Access Compliance Report Public Rights-of-Way (Curb Ramps)

Main Street: **BIRCH_ST** Cross Street: **VALENCIA_AVE** Location: **NW**

ADA ID: **RPAT210920145301** Ramp Type: **Type 1 - Perpendicular** Initial Pass/Fail: **Fail** Overall Compliance: **No** Severity Score: **15**

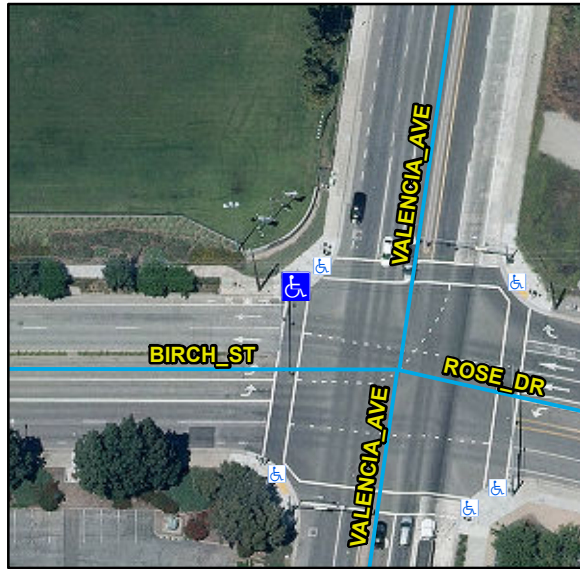
Compliance	Description	Data	Compliance	Description	Data
N/A	Ramp Length (in)	94	N/A	Flare Type LT	
Yes	Ramp Width (in)	60			N/A
Yes	Ramp Run Slope (%)	6.7	N/A	Flare Slope LT (%)	N/A
No	Ramp Cross Slope (%)	5.2	N/A	Flare Traversable LT	N/A
N/A	Landing Present	N/A	N/A	Flare Type RT	
N/A	Landing Length (in)	N/A			N/A
N/A	Landing Width (in)	N/A	N/A	Flare Slope RT (%)	N/A
N/A	Landing Run Slope (%)	N/A	N/A	Flare Traversable RT	N/A
N/A	Landing Cross Slope (%)	N/A	N/A	DWS Provided	N/A
N/A	Landing Movement Obstructed?	N/A	N/A	DWS Contrast	N/A
	Landing Movement Type	N/A	N/A	DWS Length (in)	N/A
N/A	Landing Shared	N/A	N/A	DWS Full Width	N/A
N/A	Clear Space	N/A	N/A	DWS Offset Left (in)	N/A
N/A	Clear Space To Crosswalk (in)	N/A	N/A	DWS Offset Right (in)	N/A
N/A	Marked Crosswalk 1	Yes	N/A	Marked Crosswalk 2	N/A
	Crossing 1 Direction	S		Crossing 2 Direction	N/A
	Marked Crosswalk 1 Width (in)	120		Marked Crosswalk 2 Width (in)	N/A

Remove & Replace Entire Ramp.

R304.5.3, STD 1115
